| CAP Aviation 9, rue de l'Aviation 21121 DAROIS - France Tel +33 380 35 65 10 Fax +33 380 35 65 15 www.capaviation.com | S E R V I C E B U L L E T I N | |
| 001102 | Engine cowl angle bracket | 71 |

To inform users about angle brackets installing possibility at the bottom of firewall to improve engine cowl mounting for CAP 232, serial Nr 001 to 018 included.

Figure 1

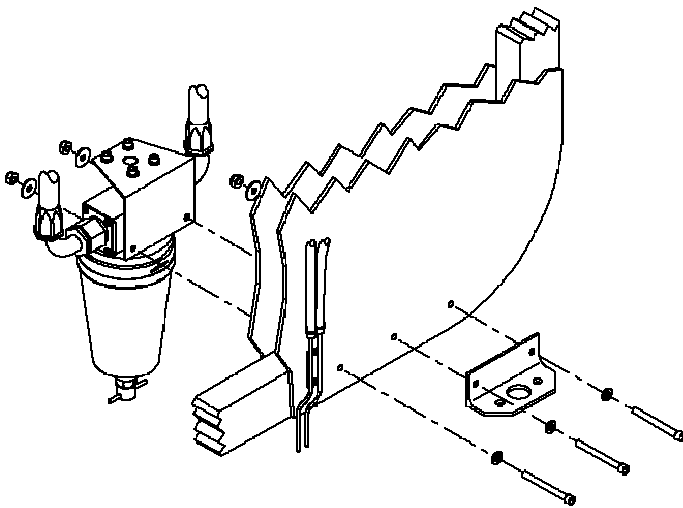
- (A) Put left angle bracket in place sharing the fuel filter external screw (refer to fig. 1).

Figure 2

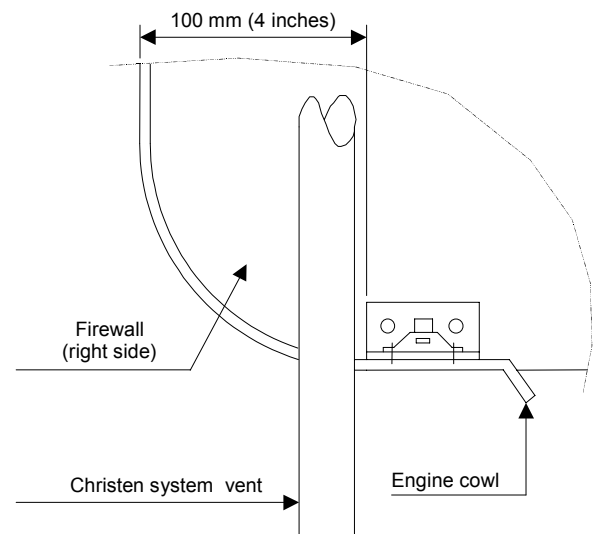
- (B) Drill a 5 mm hole into the firewall bottom part for the second screw.
- (C) Put second angle bracket on right side at 100 mm (4 inches) from fuselage flank (refer to fig. 2).
- (D) Drill two 5 mm holes into the firewall bottom part to install the right angle bracket.
- (E) Put in place upper and lower engine cowls.
- (F) Mark and locate fixation holes with engine cowl and angle bracket positioned.
- (G) Remove lower engine cowl.
- (H) Drill holes into engine cowl (refer to fig.3).
- (I) Countersink angle bracket holes to flush rivets heads.
- (J) Rivet captive nuts on each angle bracket after having inserted the two plates (refer to fig. 4). If the engine cowl is too thick, the screw may not have enough length in the nut. In that case, only one plate may be inserted. Check if the screw is not stop at the end of the nut in stead of tightening the engine cowl.

Fig. 1 - Capotage

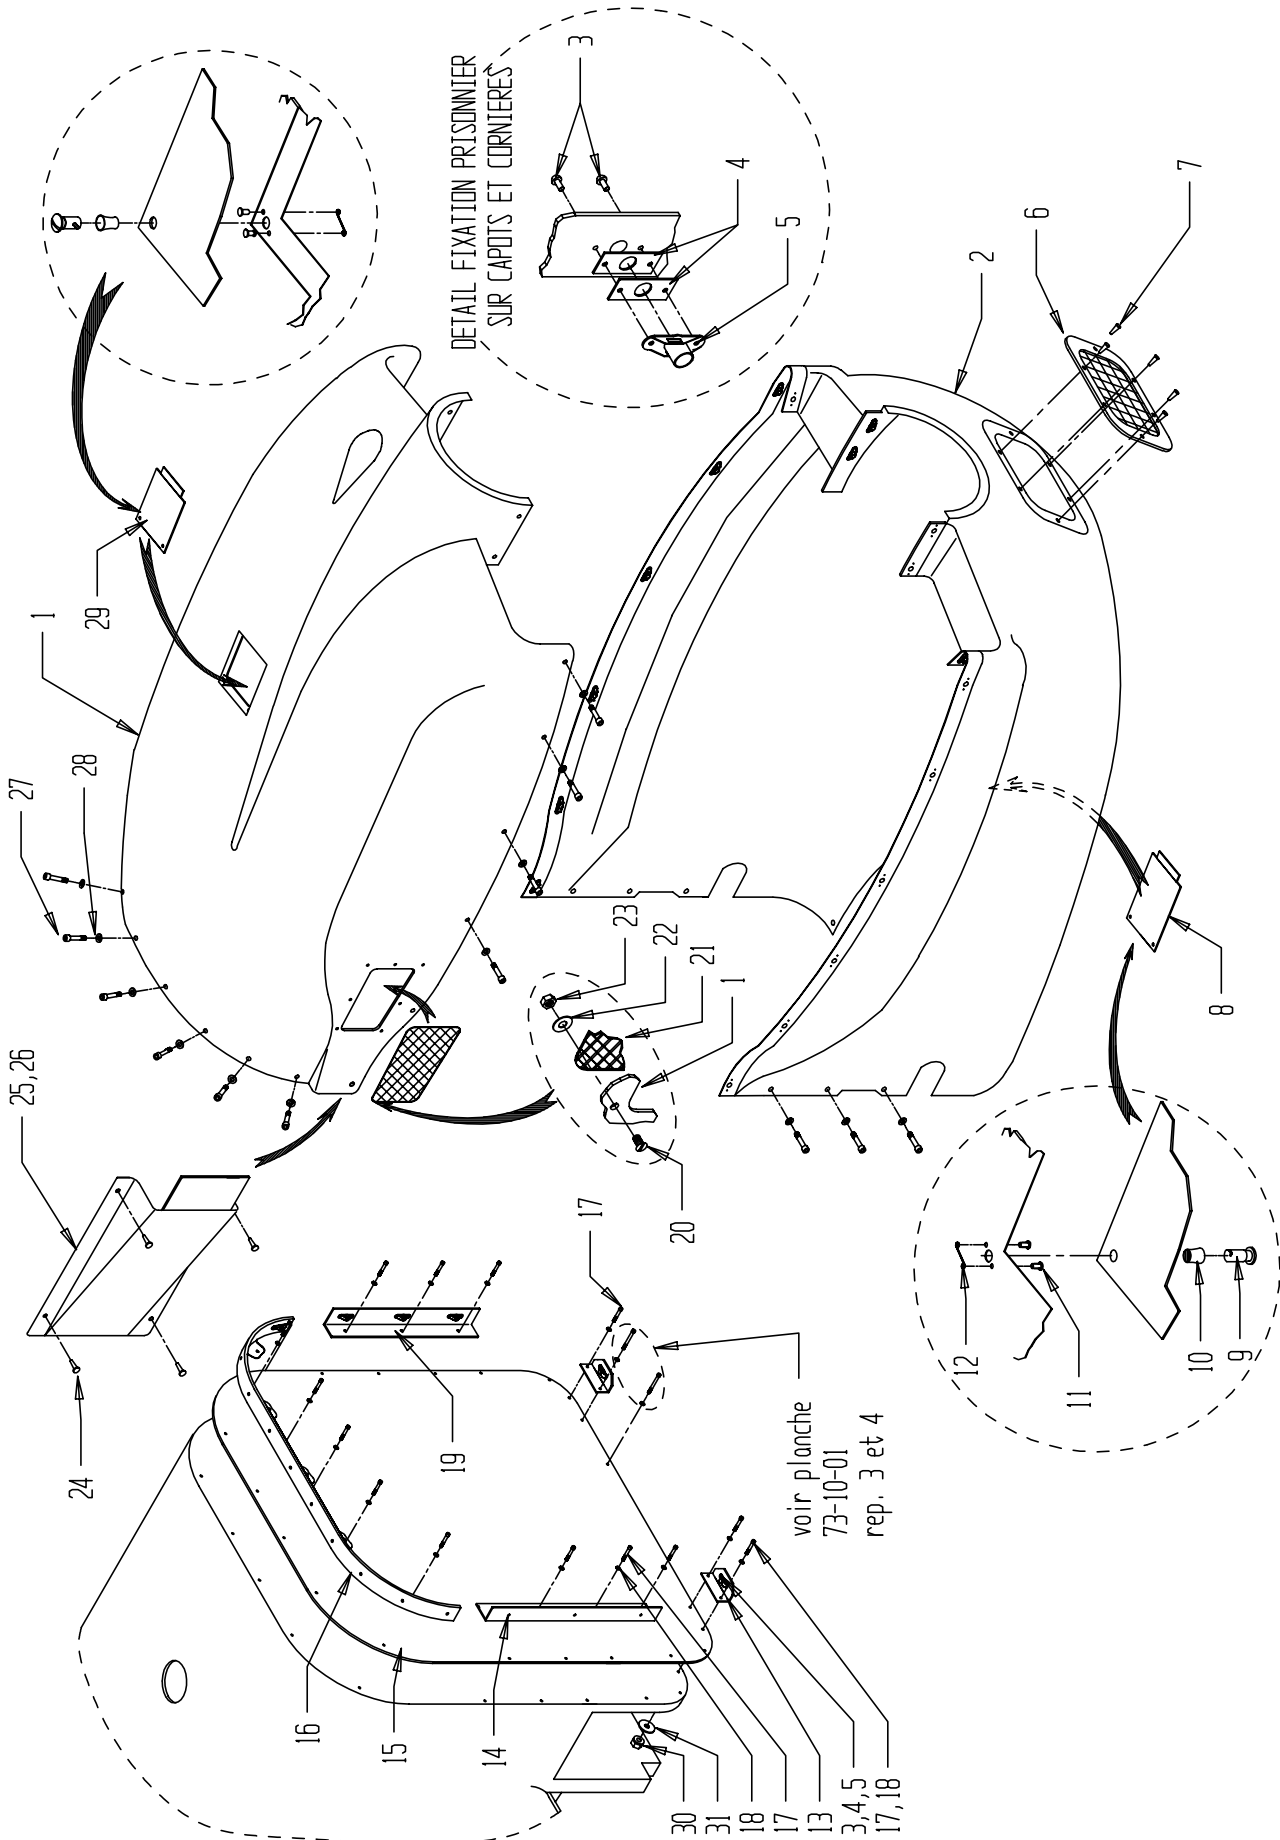
Engine cowl is fastened on firewall by means of three support angles ⁽¹⁾ on which 17 captive nuts are located ⁽²⁾. On Nr 001 to 018 aircraft, it is recommended to improve engine cowl mounting by installing two angle brackets , each of them equipped with captive nuts as well.

⁽¹⁾: CAP232 Illustrated parts catalogue, page 71-10-01, items 16, 14 & 19.

⁽²⁾: CAP232 Illustrated parts catalogue, page 71-10-01, item 5.
